November 17, 2020

NOTICE OF ADDENDUM  
ADDENDUM NO. 1  
CONTRACT NO. 8498  
ROCKSTREAM DRIVE ASSESSMENT DISTRICT – 2020

**STORM DETAIL 2: CULVERT RAILING DETAILS**

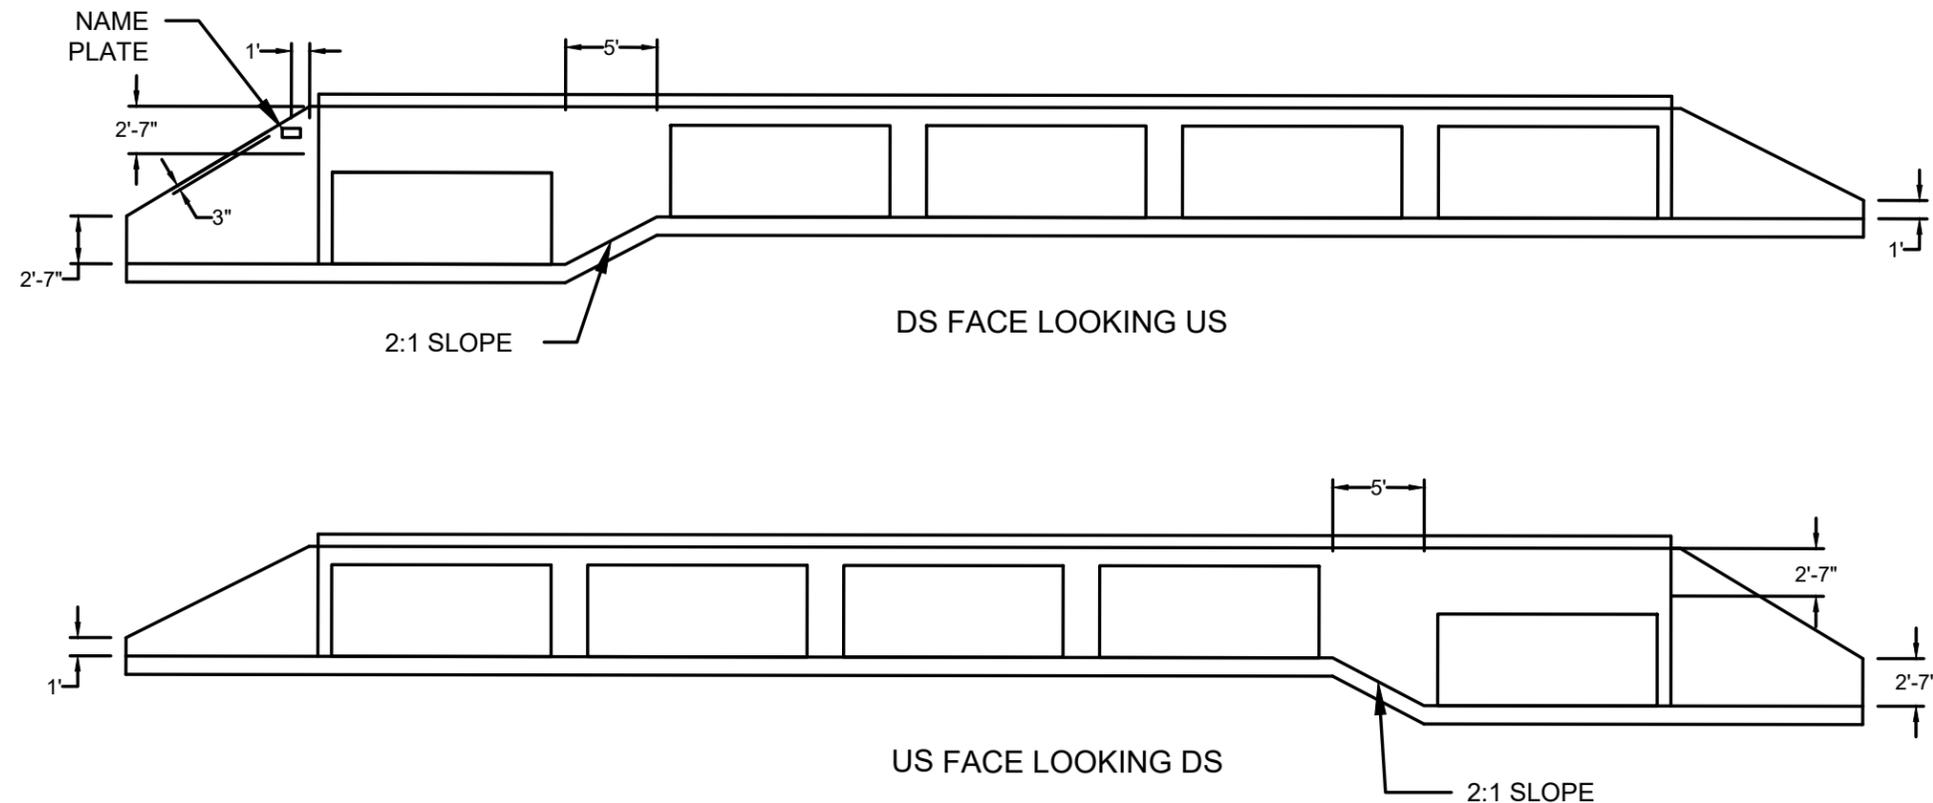
U-7: Railing detail added.

MARK	REVISION	DATE	BY
1	ADDED RAILING DETAIL	11/13/2020

RAIL SHALL BE PAINTED BLACK (RAL 9005 OR EQUIVALENT).

ALL PIPES SHALL BE CUT TO FIT AND JOINTS SHALL BE WELDED CONTINUOUSLY AROUND THE PERIMETER TO ENSURE A BURR FREE AND STRUCTURALLY SOUND CONNECTION.

IN ON A SLOPE, THE POSTS SHOULD REMAIN VERTICAL AND THE RAILS SLOPED WITH THE GROUND OR WINGWALL.
